Access Compliance Report Public Rights-of-Way (Curb Ramps)

Main Street: ORANGEWOOD_AVE Cross Street: DALE_ST Location: NW

ADA ID: RPRK210928112813 Ramp Type: Type 1 - Perpendicular Diagonal Initial Pass/Fail: Fail Overall Compliance: No Severity Score: 2

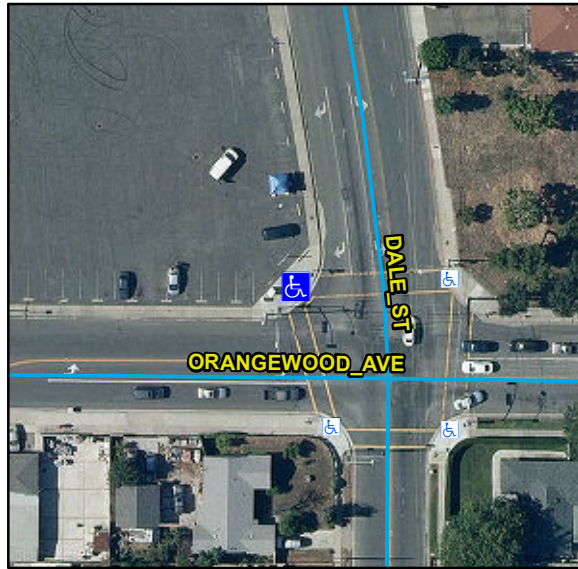
R204.3, R304.5.3, STD 1115

Remove & Replace Curb Ramp With Two New Directional Ramps or Equivalent.
